SBR Battery

Feature Update

June.2nd, 2022 Feature Update

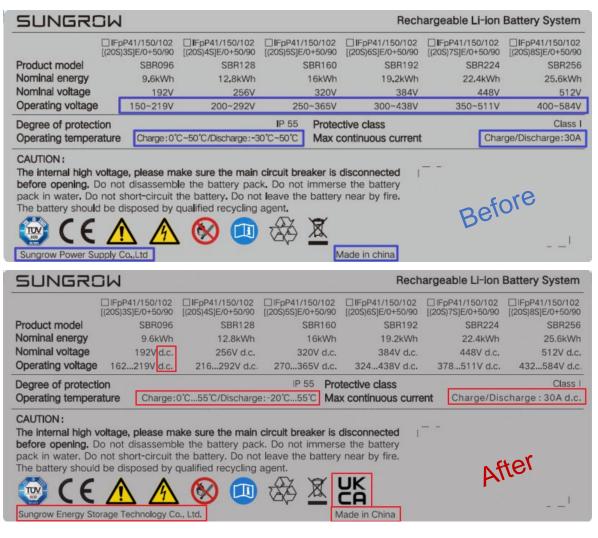
- Label information changes
 - a) Add "d.c." after the voltage and current;
 - b) Voltage and temperature range marking changes;
 - c) Add the UKCA certification mark to the nameplate;
 - d) The main company changed to "Sungrow Energy Storage Technology Co., Ltd.";
 - e) "Made in china" changed to uppercase
